## RPRC RETURN LETTER

Application Number: 2021-0980

Street Location: 45 BYRAM RIDGE RD

**Re: 45 Byram Ridge Rd – Section 101.03 Block 3 Lot 24**

**Landscape Plan**

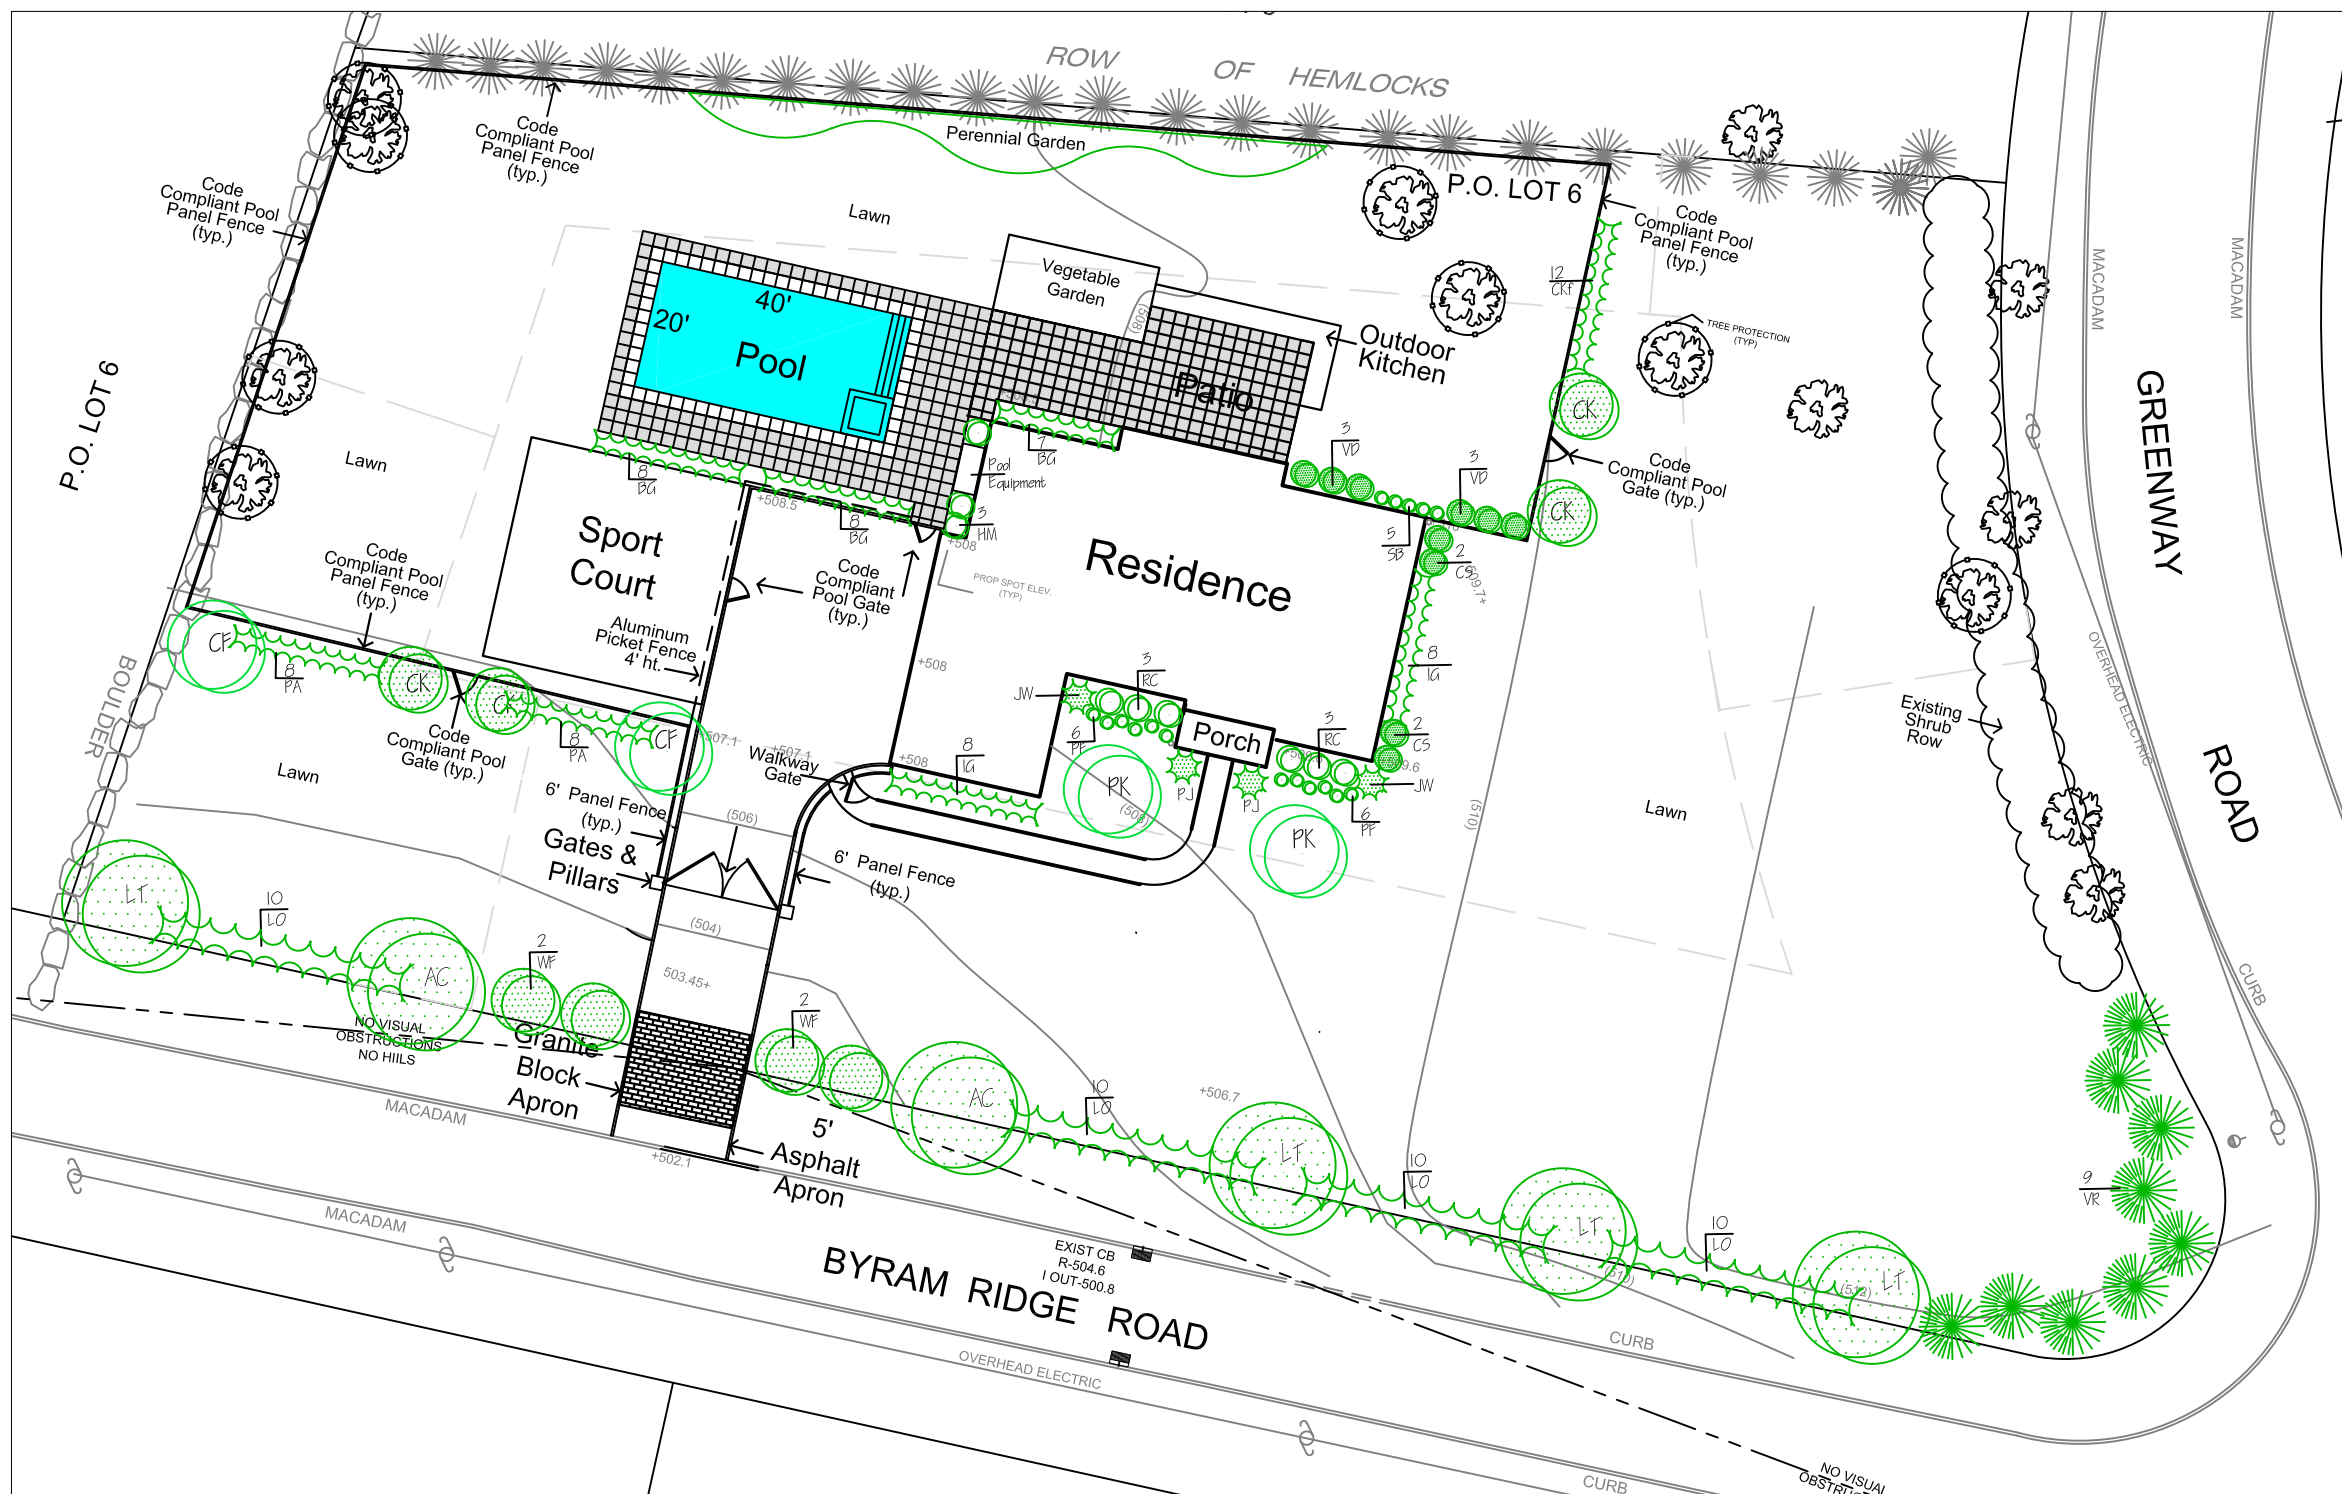
- The Applicant should submit a gross floor area calculations worksheet and backup exhibit.
- The site plan should include a detail for the proposed driveway gate and pillars.

- **Site plan now shows detail for proposed driveway gate and pillars. Same detail is provided as part of the landscape plan by Stephen Lopez, RLA.**
